Access Compliance Report Public Rights-of-Way (Curb Ramps)

Main Street: GRAMERCY_DR Cross Street: ESPLANADE_AVE Location: SW

ADA ID: RPAT211025114936 Ramp Type: Type 4 - Parallel Initial Pass/Fail: Fail Overall Compliance: No Severity Score: 2

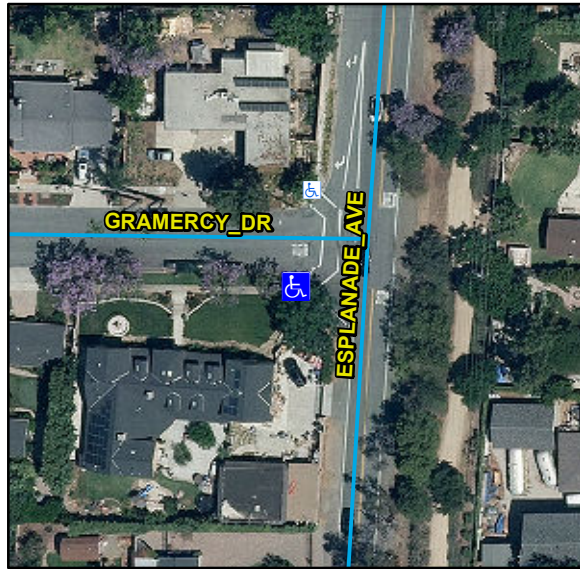
Compliance	Description	Data	Compliance	Description	Data
N/A	Ramp Length LT (in)	95	N/A	Ramp Length RT (in)	51
Yes	Ramp Width LT (in)	59	Yes	Ramp Width RT (in)	75
Yes	Ramp Run Slope LT (%)	8	Yes	Ramp Run Slope RT (%)	7.1
No	Ramp Cross Slope LT (%)	3.5	Yes	Ramp Cross Slope RT (%)	0.1
N/A	Landing Present	N/A	N/A	DWS Provided	N/A
N/A	Landing Length (in)	N/A	N/A	DWS Contrast	N/A
N/A	Landing Width (in)	N/A	N/A	DWS Length (in)	N/A
N/A	Landing Run Slope (%)	N/A	N/A	DWS Full Width	N/A
N/A	Landing Cross Slope (%)	N/A		DWS Offset Type	N/A
N/A	Landing Movement Obstructed?	N/A	N/A	DWS Offset Left (in)	N/A
	Landing Movement Type	N/A	N/A	DWS Offset Right (in)	N/A
N/A	Landing Shared	N/A			
N/A	Clear Space	N/A			
N/A	Clear Space To Crosswalk (in)	N/A			
N/A	Marked Crosswalk 1	Yes	N/A	Marked Crosswalk 2	N/A
	Crossing 1 Direction	N		Crossing 2 Direction	N/A
	Marked Crosswalk 1 Width (in)	120		Marked Crosswalk 2 Width (in)	N/A

Remove & Replace Entire Ramp.
